ADDENDUM NUMBER 1

PROJECT: 46 KV Transmission Line – 2024 Modifications & Additions
City of Fairhope (**BID NO. 25-003**)

FROM: Stewart Engineering, Inc.
PO Box 2233
Anniston, AL 36202
(256) 237-0891

2. **DRAWING NO. AX23103-1 – Sheets 1, 6, 7, 11, 12, 13, & 14**

CITY OF FAIRHOPE	
46KV TRANSMISSION LINE - 2024	
MODIFICATIONS & ADDITIONS ALTERNATE #2	
DRAWN BY: ACG	DATE: 10-10-24
APPROVED BY: JLJ	DATE: 10-10-24
DWG#: AX23103-1	STEWART ENGINEERING
SHEET: 13 OF 15	ELECTRICAL CONSULTANTS
SCALE: AS NOTED	ANNISTON, ALABAMA
	PHONE: (256)237-0891

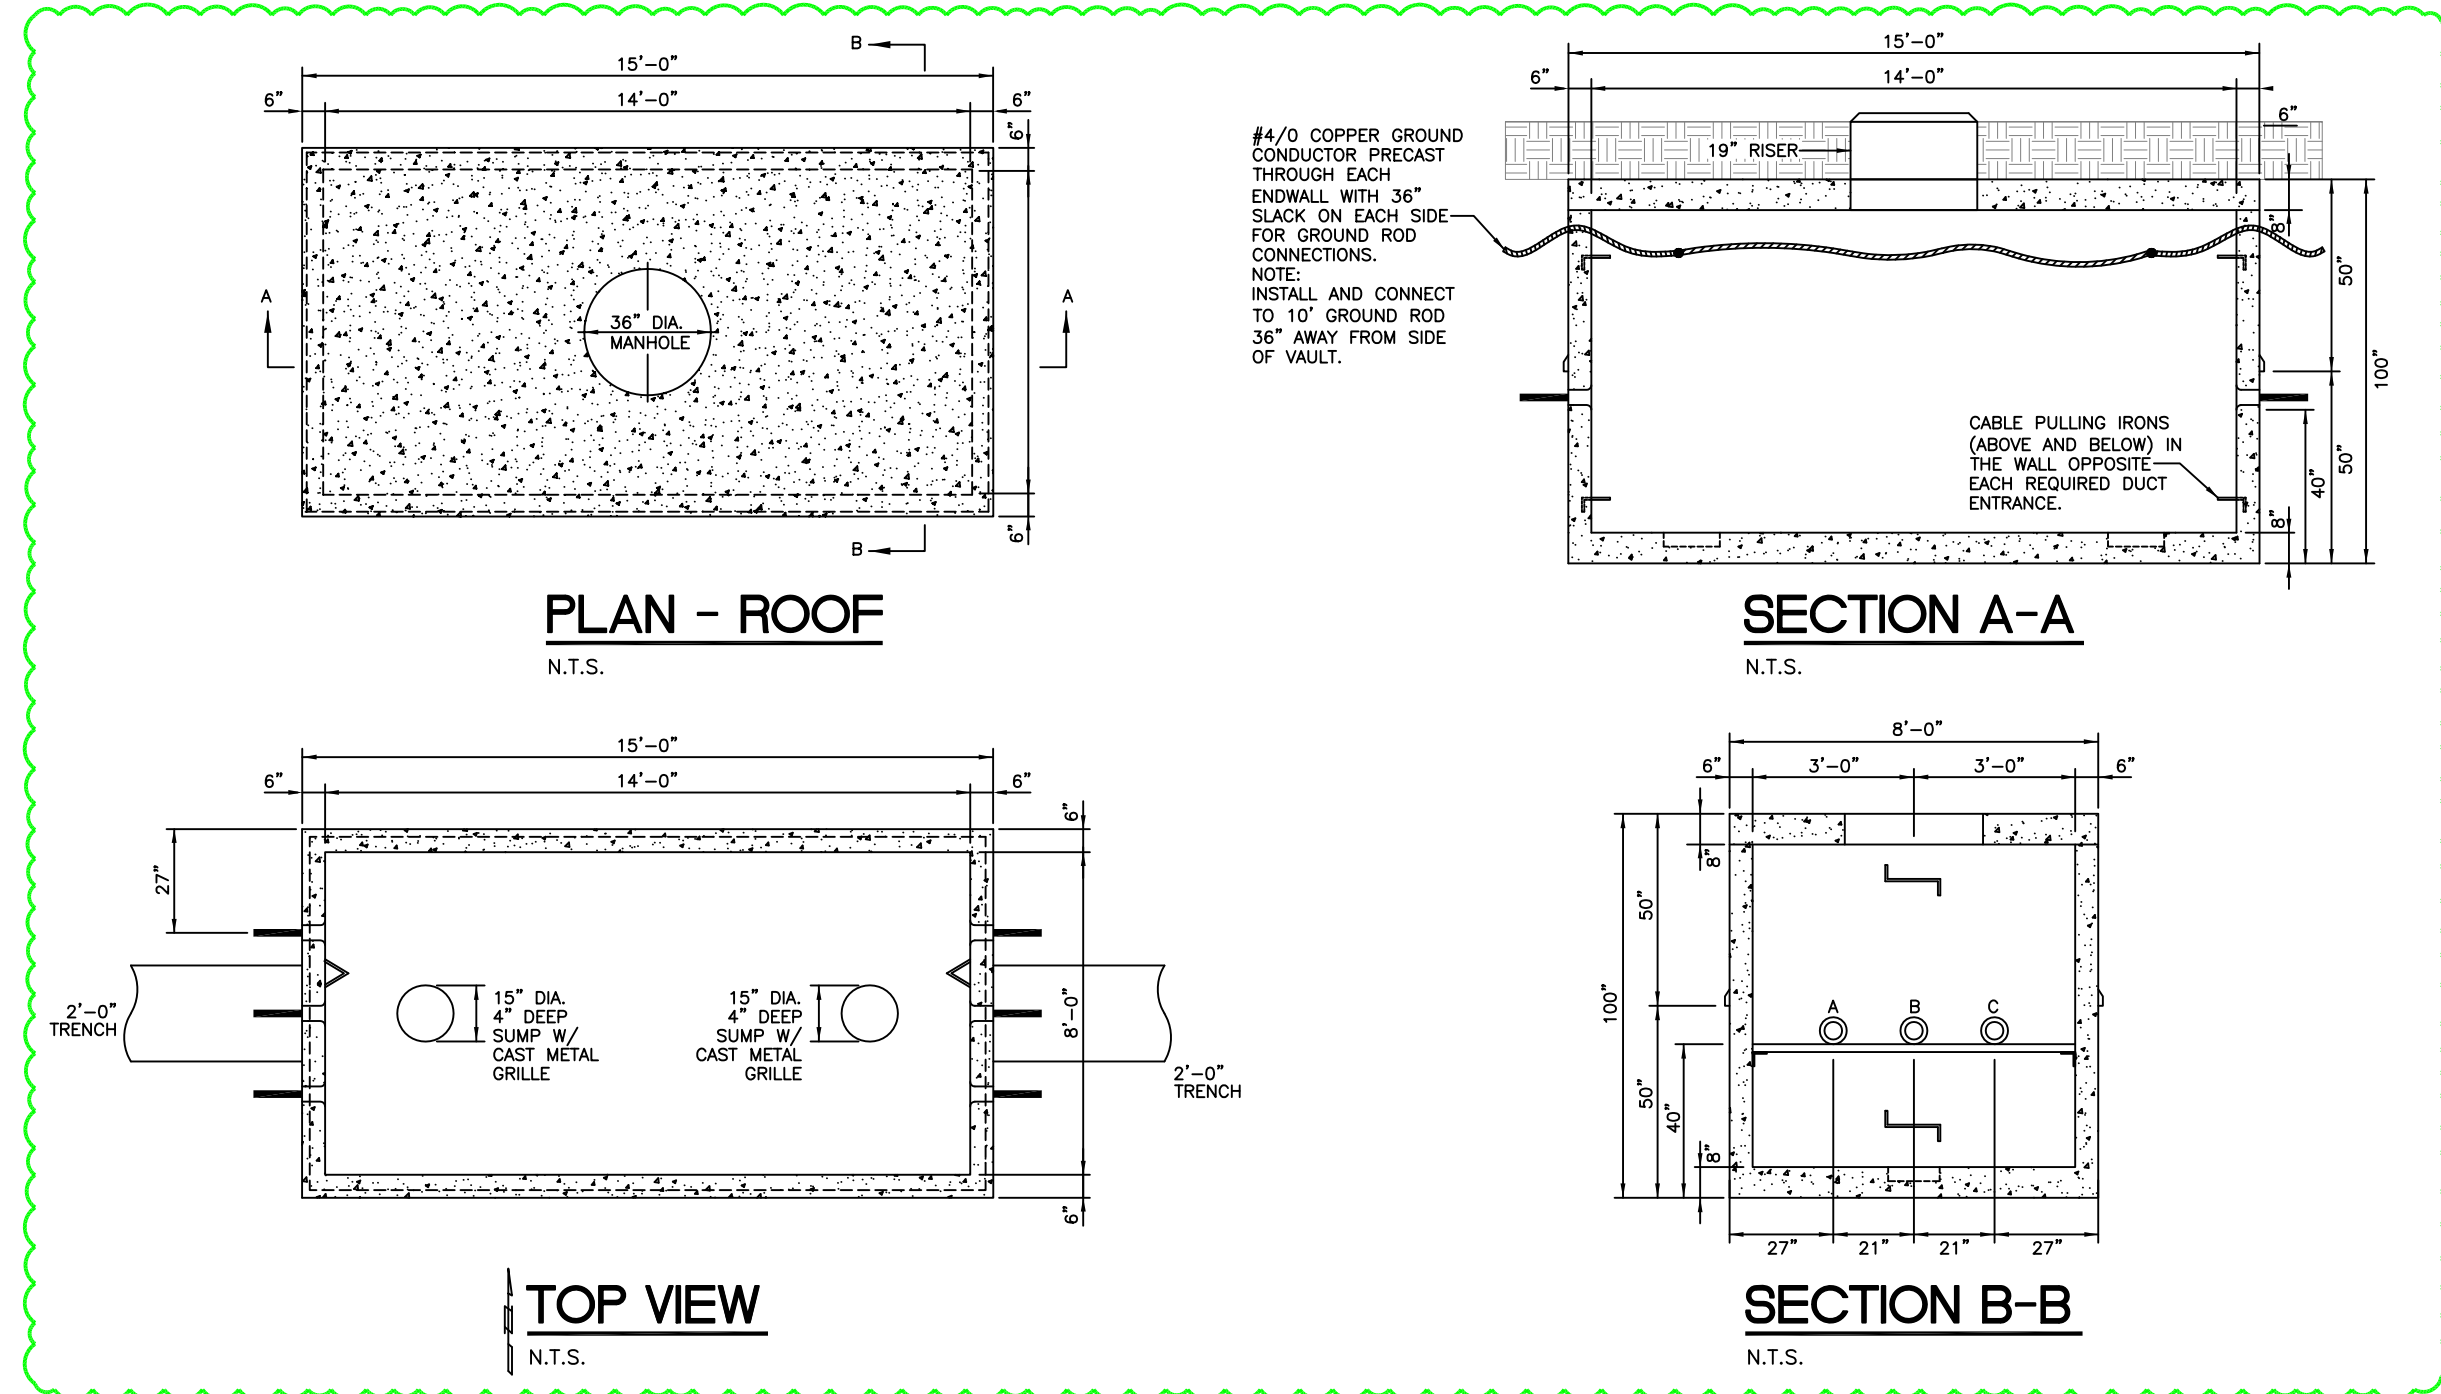
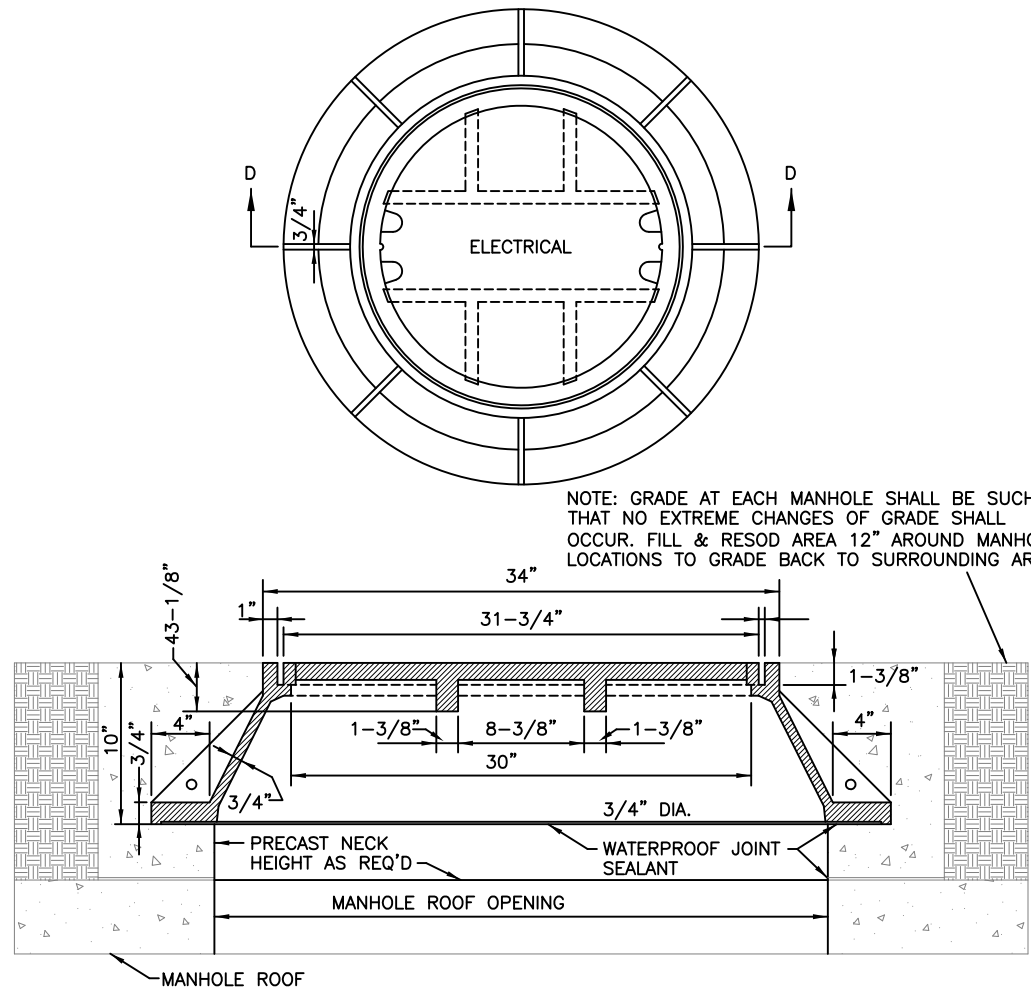
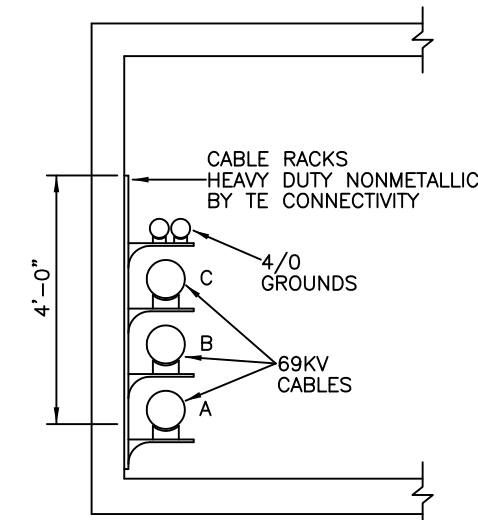
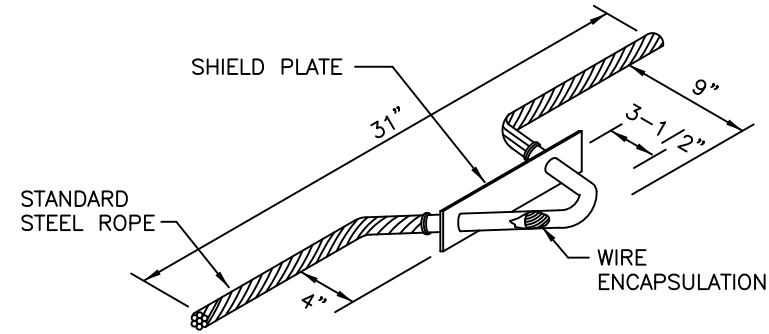
ADDENDUM #1 - 10-23-24
REVISED TO REFLECT CHANGES
ALONG MORPHY AVE. AND TO
46KV VAULTS.

CITY OF FAIRHOPE	
46KV TRANSMISSION LINE - 2024	
MODIFICATIONS & ADDITIONS ALTERNATE #2	
DRAWN BY: ACG	DATE: 10-10-24
APPROVED BY: JLJ	DATE: 10-10-24
DWG#: AX23103-1	STEWART ENGINEERING
SHEET: 14 OF 15	ELECTRICAL CONSULTANTS
SCALE: AS NOTED	ANNISTON, ALABAMA
	PHONE: (256)237-0891

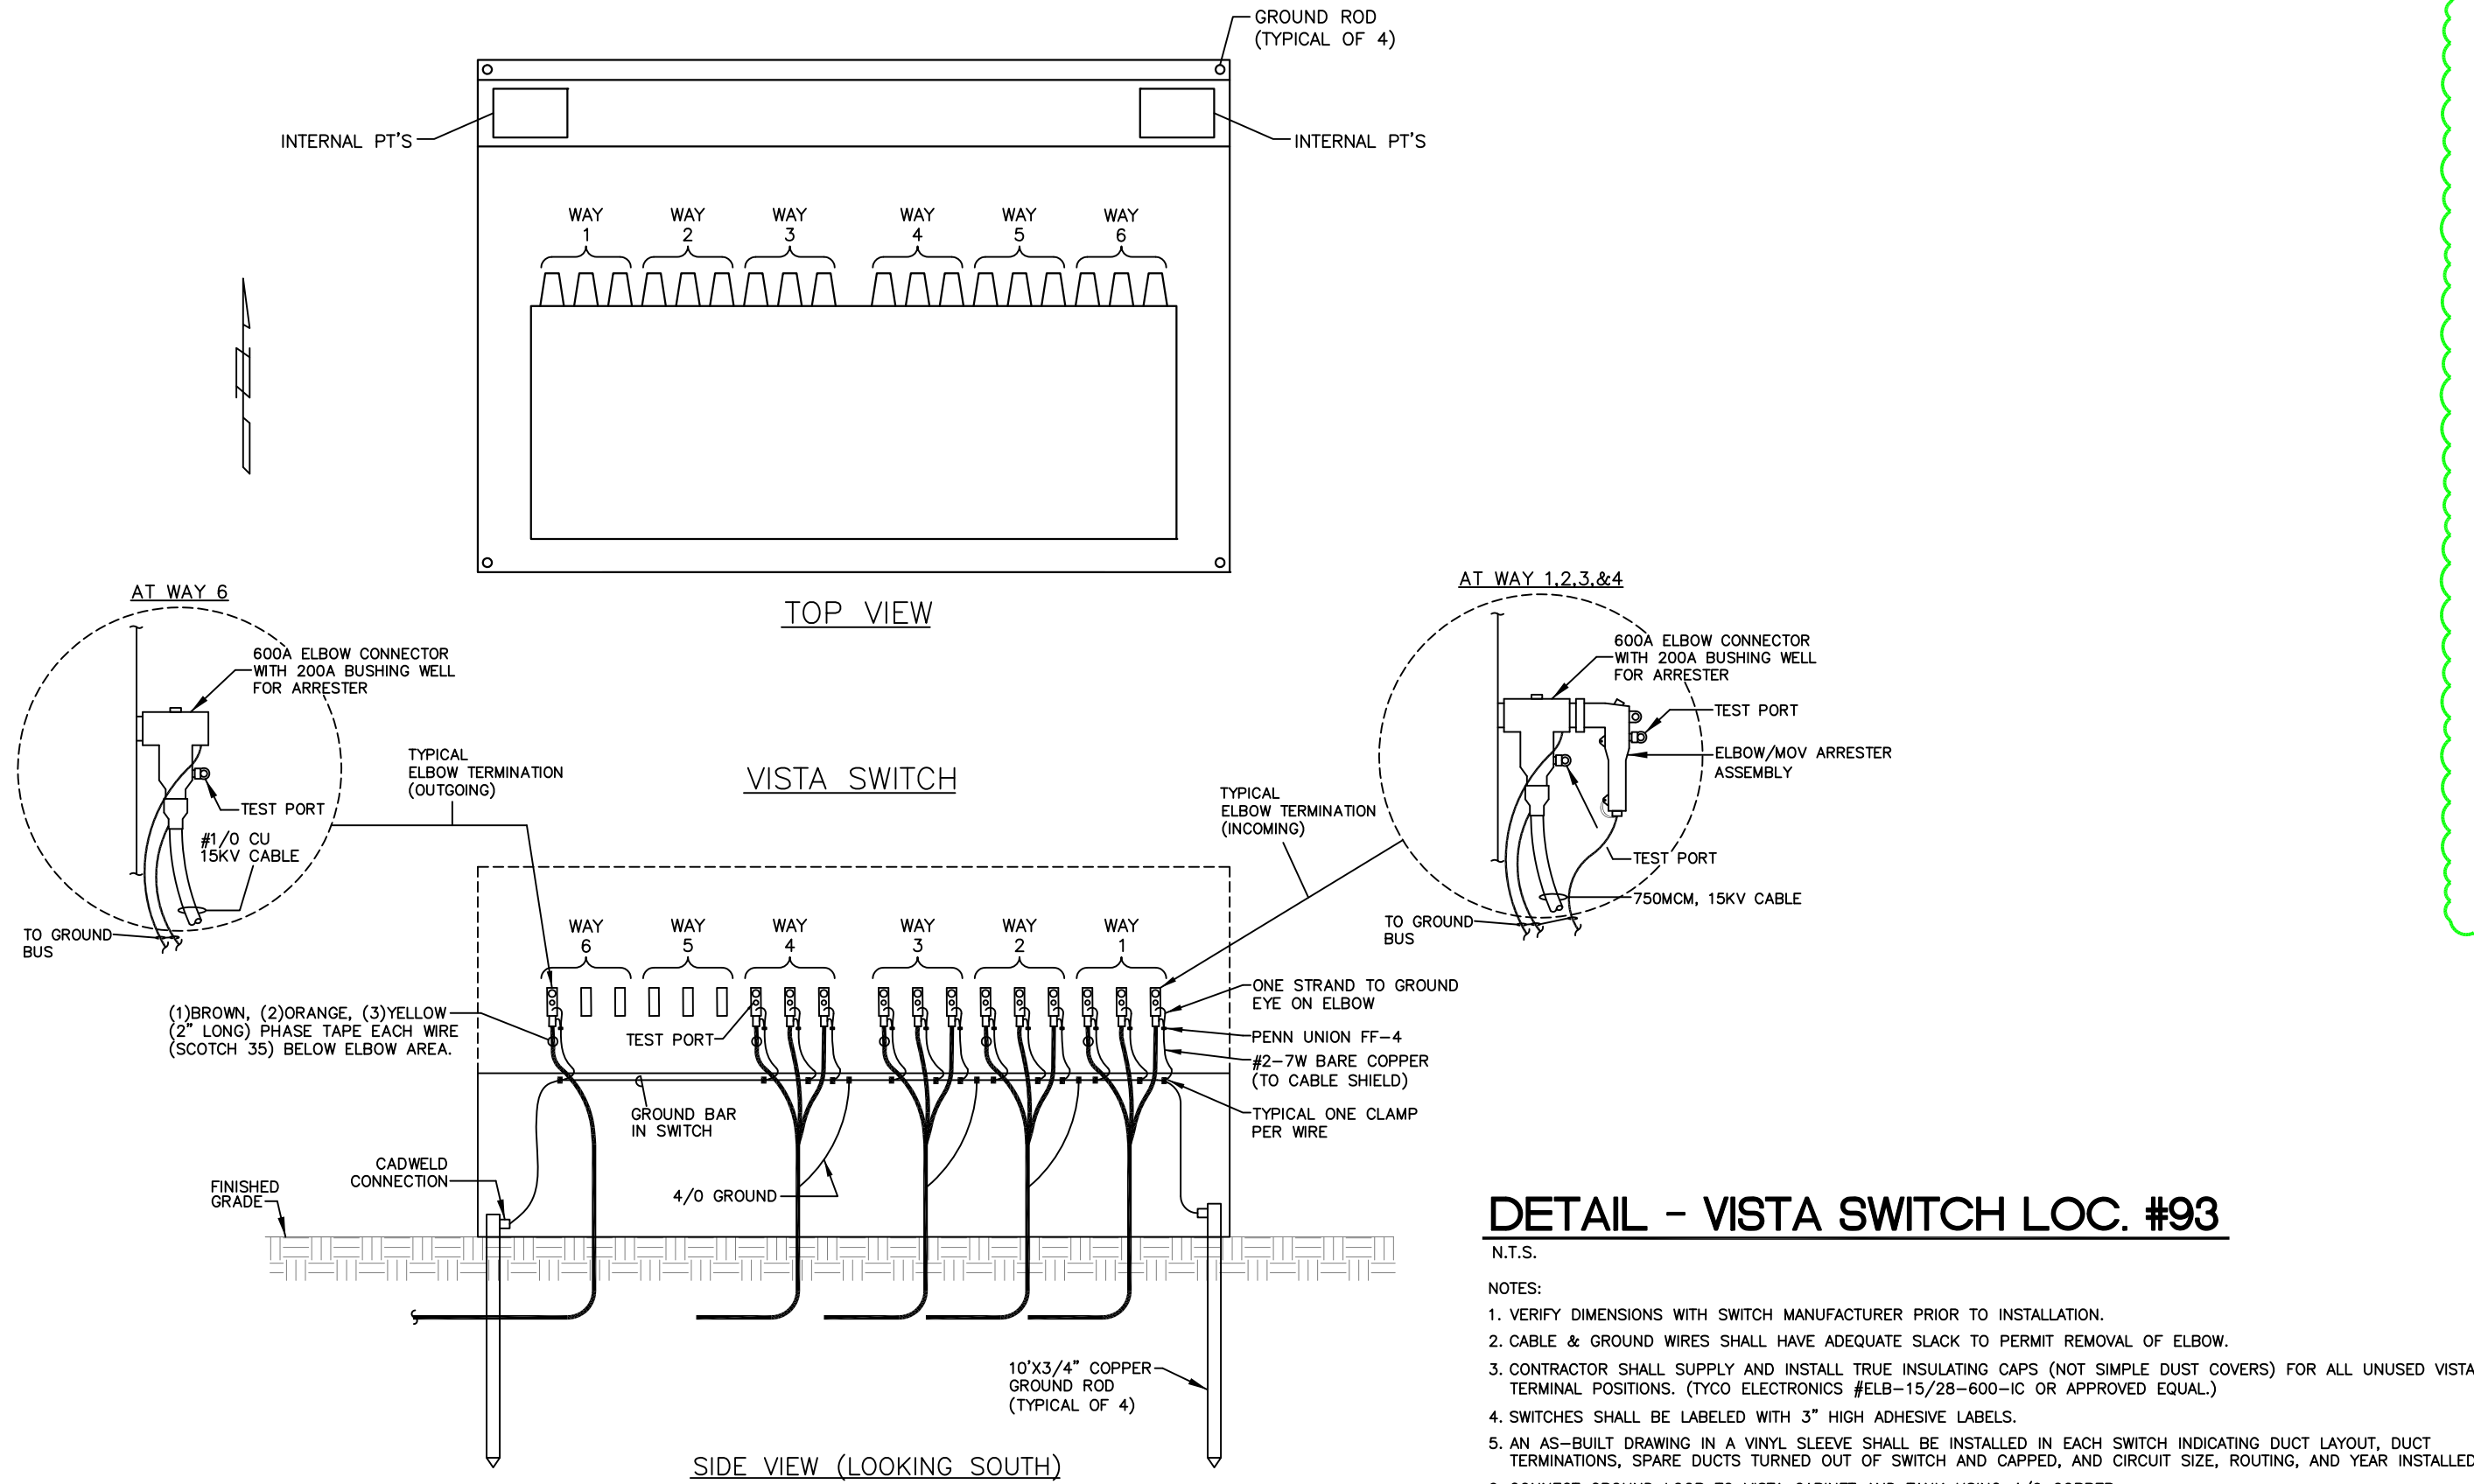
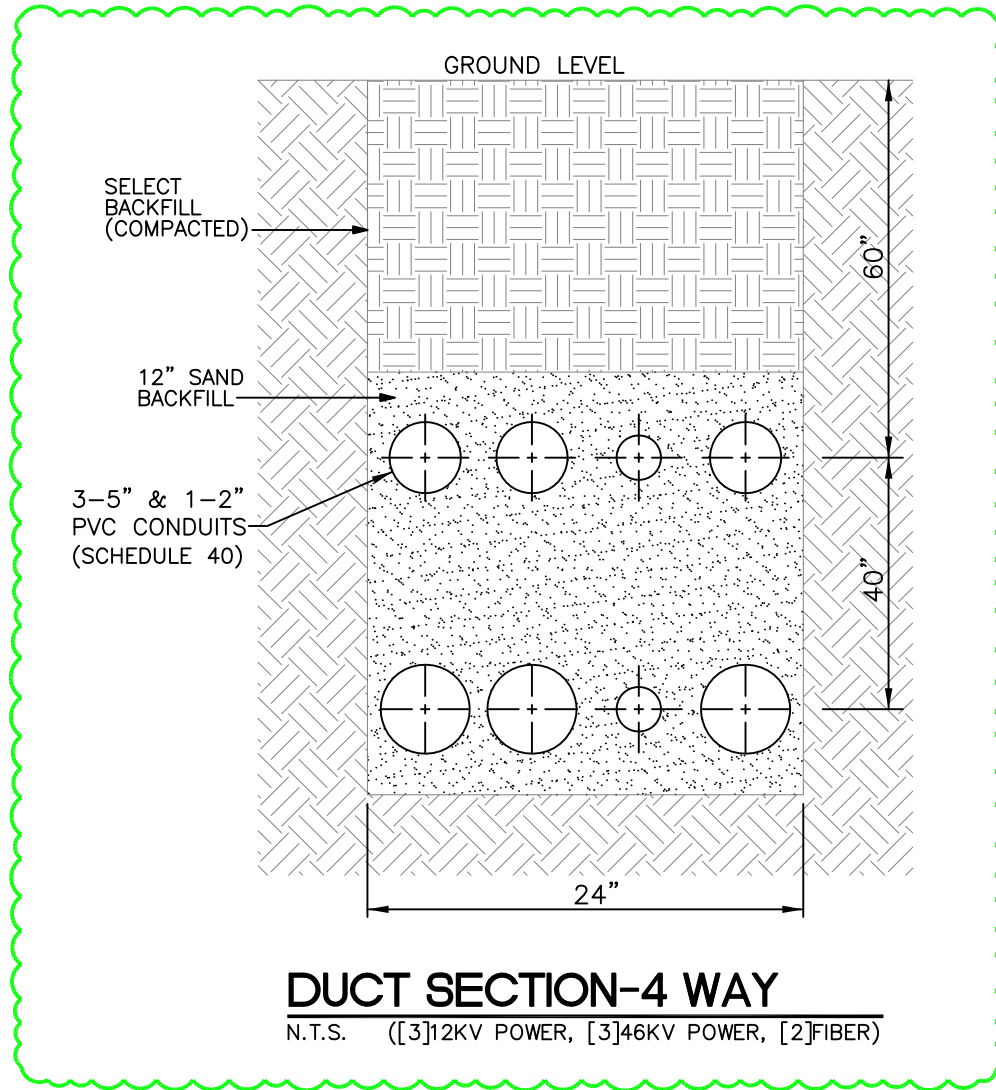
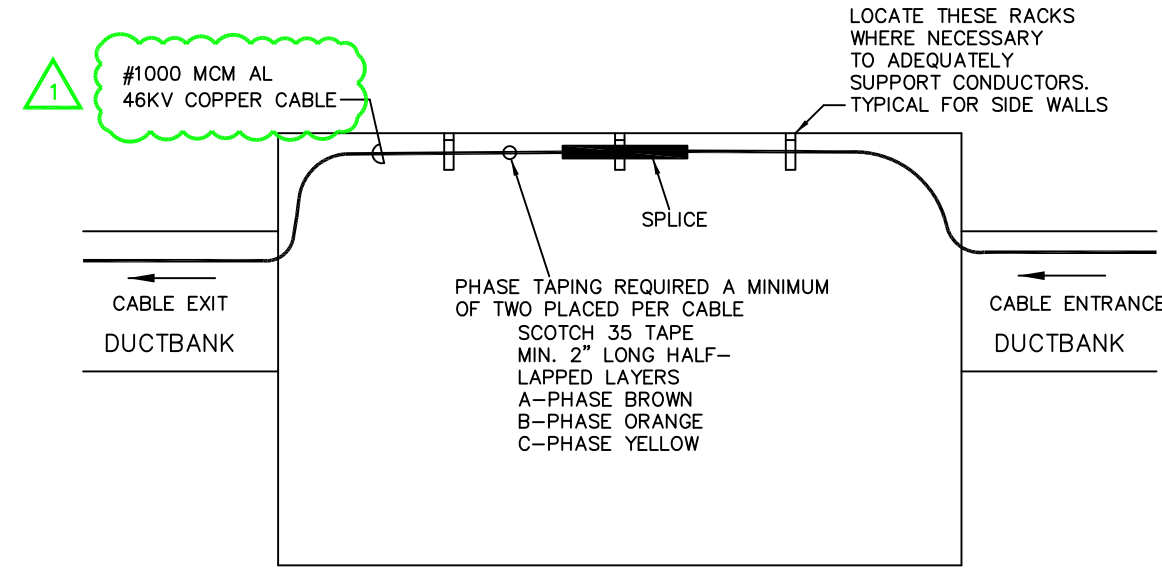
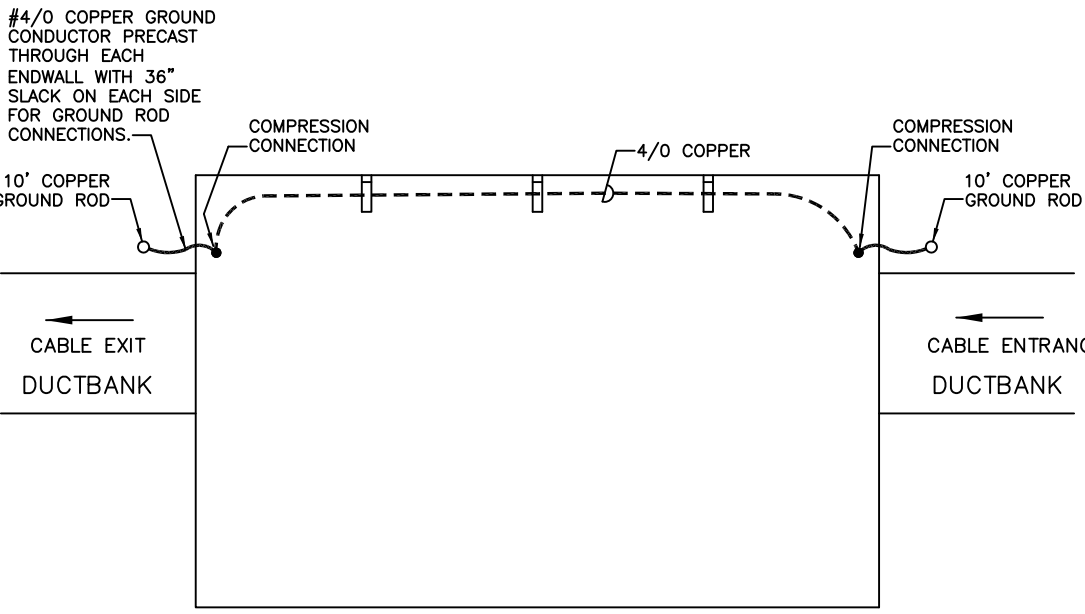
ADDENDUM #1 - 10-23-24
REVISED TO REFLECT CHANGES
ALONG MORPHY AVE. AND TO
46KV VAULTS.
